**BEFORE THE WASHINGTON UTILITIES AND TRANSPORTATION
COMMISSION**

In the Matter of the Review of)
Unbundled Loop and Switching Rates; the) DOCKET NO. UT-023003
Deaveraged Zone Rate Structure; and)
Unbundled Network Elements, Transport,)
and Termination)

**REPLY TESTIMONY OF
FRANCIS J. MURPHY
ON BEHALF OF
VERIZON NORTHWEST INC.**

HM 5.3 REVISED CRITIQUE

Diagram 2

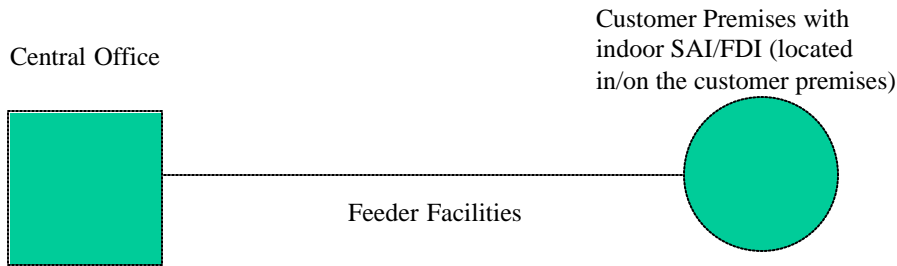
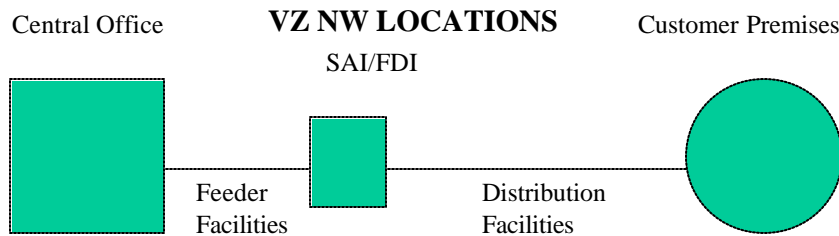
These loop design errors cause the Model to reduce substantially the lengths and costs of the feeder plant. This can be illustrated by HM 5.3 [Revised](#)'s treatment of indoor SAIs. The top of Diagram 2 below shows the real-world routing of outside plant facilities to medium and large businesses (or buildings with concentrations of residential customers) with indoor SAIs. The bottom of Diagram 2 below shows HM 5.3 [Revised](#)'s erroneous assumption that indoor SAIs will rarely be placed.

1
2 | HM 5.3 Revised avoids virtually all indoor SAI situations, placing only *eight* of
3 | them in Verizon NW's entire Washington serving area. This occurs because, to
4 | trigger an indoor SAI, HM 5.3 Revised requires that a cluster consist of less than
5 | 0.0004 square miles. TNS creates such clusters for any single location with over
6 | 536 lines.⁴² In addition, only four of the eight indoor-SAI locations modeled by
7 | HM 5.3 Revised are served by fiber to the premises with an indoor DLC, an

CHART 1 (revised June 18, 2004)⁵⁰

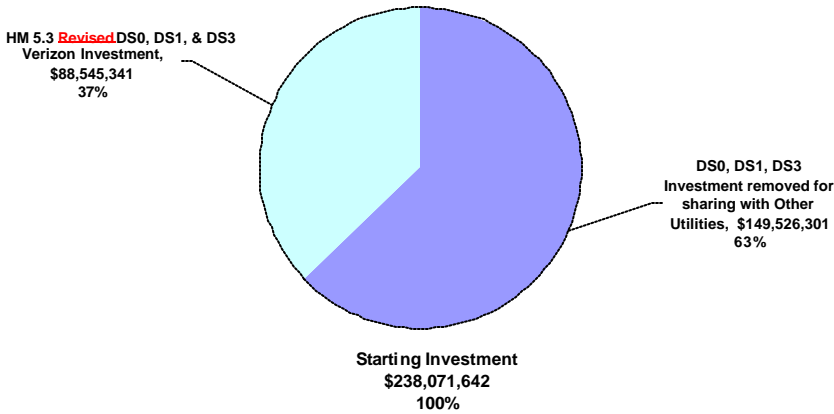
Chart 2 below shows how the remaining distribution structure investment of \$88,545,341 is further reduced based on the unsubstantiated opinions of the HM 5.3 model developers regarding the assignment of structure investments and the so-called sharing of this structure between segments of outside plant. An additional \$9,444,104 (11 percent of the remaining distribution structure investment) is removed due to sharing with feeder facilities, and \$7,868,396 (over 9 percent of the remaining total) is removed to account for high-capacity investment that is not "at issue in this proceeding."⁵¹ This leaves a mere \$71.2 million in distribution structure investment -- 30 percent of the original amount.

1 While the Model sponsors refer to the removed investments as “shared,” the
2 investment dollars computed in HM 5.3 Revised, and identified in these charts,
3 are not shifted from one part of the network to the other -- they are removed
4 entirely, and thus are never captured in any of the calculations used to develop
5 AT&T/MCI's proposed UNE prices.

Diagram 4

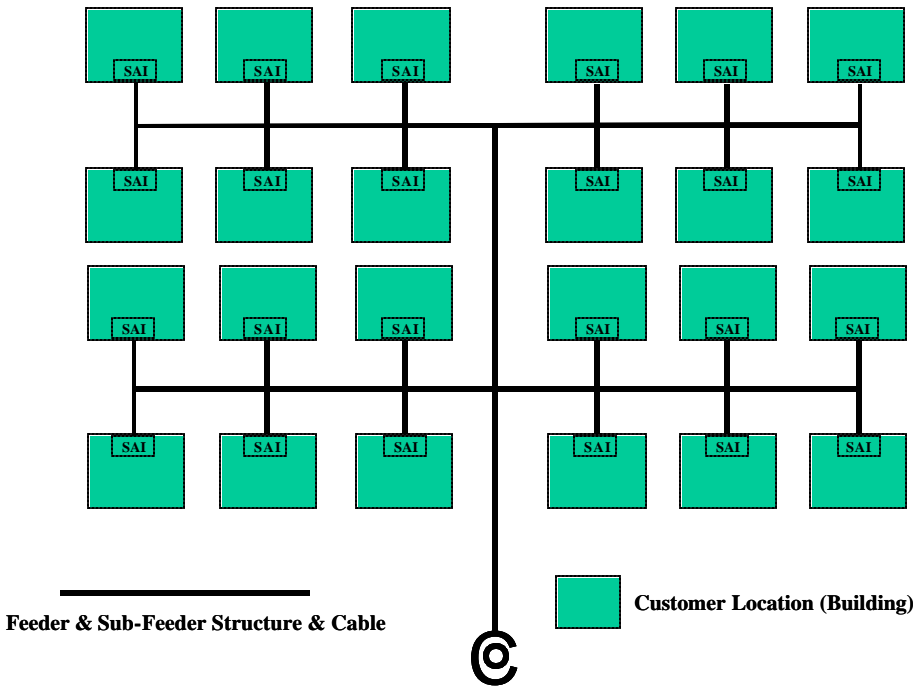
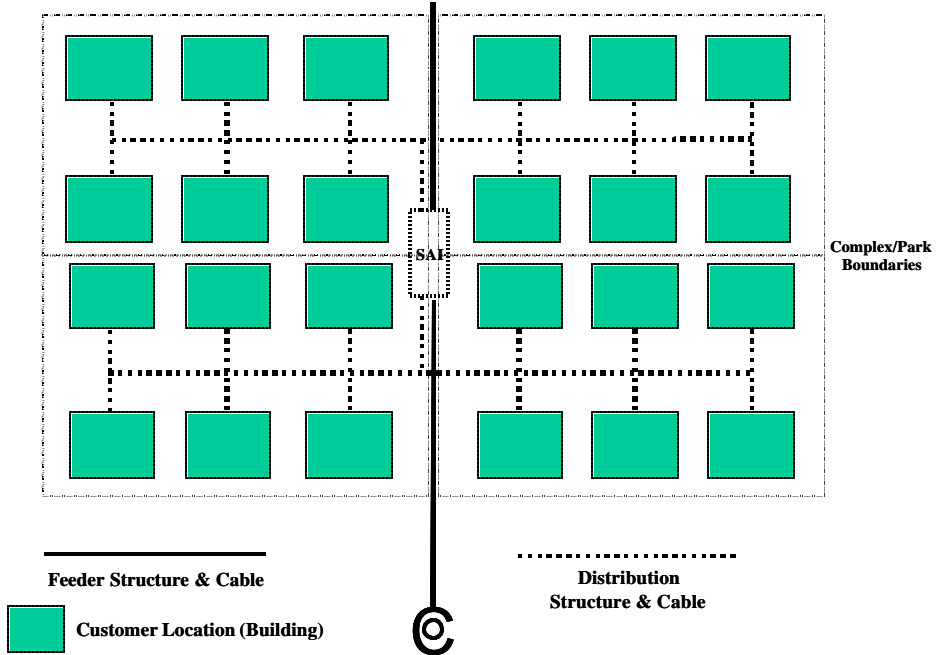
1 Q. CAN THESE CONCERNS BE ADDRESSED BY INVOKING THE OPTION TO
2 LIMIT THE SIZE OF THE SAI BY CREATING ADDITIONAL, SMALLER DAS
3 AND ADDING SUB-FEEDER CABLE?

DIAGRAM 5

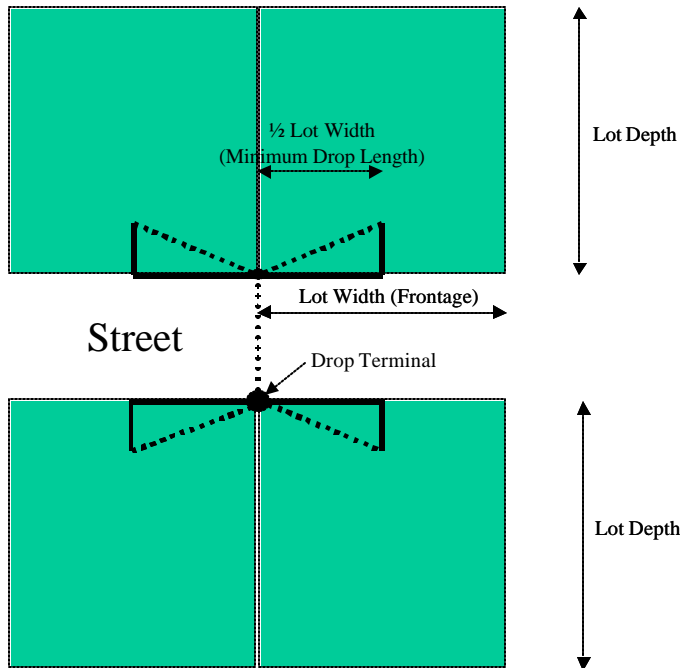
1 second analysis highlights the danger of using national averages for input values.
2 In HM 5.3 Revised, drops are assumed to run from shared terminals located at
3 the front of the property line to NIDs on each customer premises, as shown on
4 Diagram 5.

9
10 It is obvious from the lower shaded area of the diagram that the minimum drop
11 length for the customer premises located on the same side of the street as the
12 drop terminal is $\frac{1}{2}$ the lot frontage. (Even longer drops are required to serve the
13 two customer premises on the opposite side of the street.) When I compared the

Diagram 7

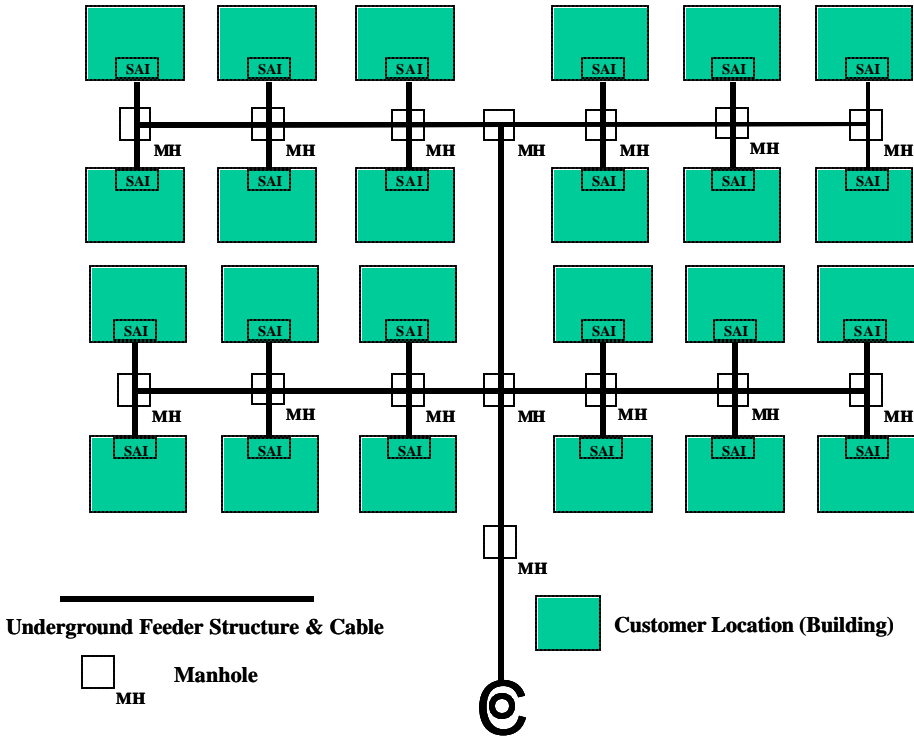
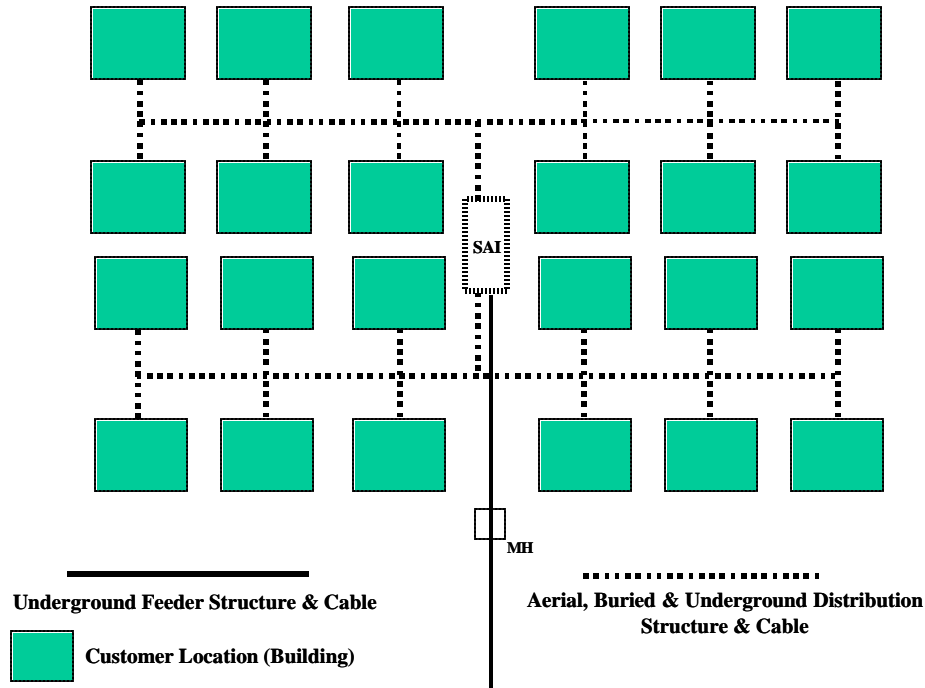
1 Even AT&T/MCI's outside plant consultant, Mr. Donovan, agrees that, in
2 downtown areas, designing each building as a DA is the current and appropriate
3 engineering loop design plan:

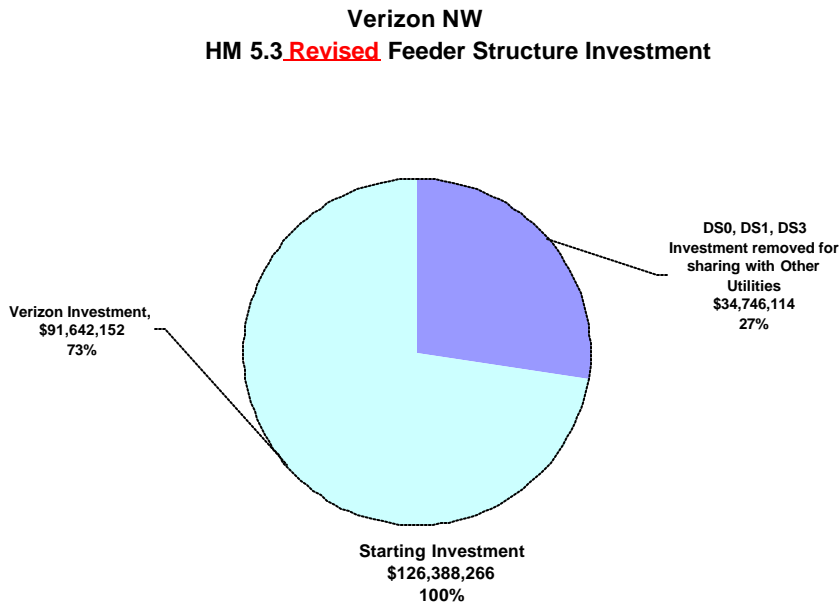
1 with other utilities, and thus are removed from the feeder structure investment.
2 As can be seen from this chart, \$34,746,114 (27 percent of the total) of DS-0,
3 DS-1 and DS-3 investment are removed for sharing with other utilities, leaving
4 \$91,642,152 of feeder structure investment that is assigned to Verizon NW's
5 feeder facilities.

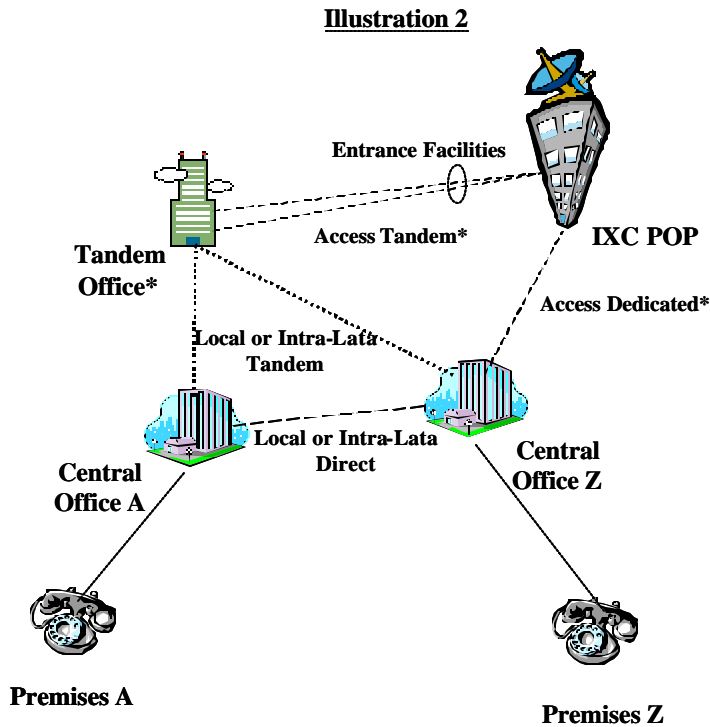
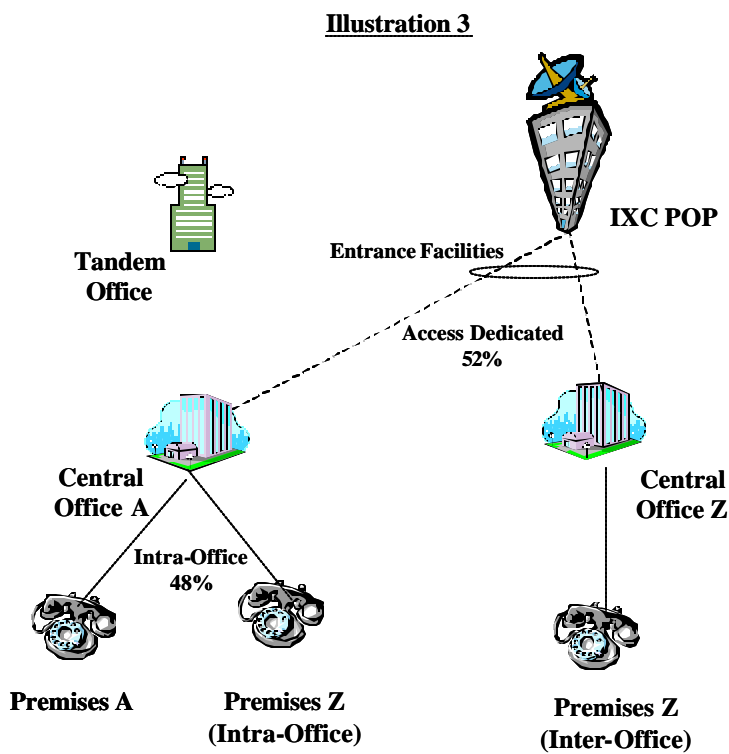
•Notes: The Model inappropriately applies the 50% reduction to all non-switched DS-1s and DS-3s including those that are Access Circuits.
In some instances, the Tandem Offices and Local Central Offices are collocated in the same wire center.

1 | Illustration 3 demonstrates the erroneous manner in which HM 5.3 [Revised](#)
2 | routes these facilities. Rather than representing the facility demand for these
3 | point-to-point private-line services properly, HM 5.3 [Revised](#) models 52 percent
4 | of the dedicated special services as special access lines routed via a pair of
5 | entrance facilities through an IXC POP.

1 As a result of this flawed modeling assumption, HM 5.3 Revised invents
2 excessive demand for dedicated entrance facilities by incorrectly assuming that
3 100 percent of the individual non-switch services and all but 50 percent of non-
4 switched DS-1 and DS-3 services require entrance facilities that terminate at an
5 IXC POP.¹⁷³ HM 5.3 Revised assumes two units of demand for entrance
6 facilities for each circuit, which then inflate the denominator used in the Model's
7 calculation of the per line Dedicated Transport Facility and Terminal costs used
8 to develop the transport UNE rates. In fact, over 400,000 point-to-point special
9 service circuits are arbitrarily included in the access direct trunk requirements,
10 while another 400,000 are simply "assumed" to traverse only local loop facilities.
11 None of these circuits are modeled on local or intra-LATA direct or tandem
12 routed facilities. By using these arbitrary assumptions rather than the actual data
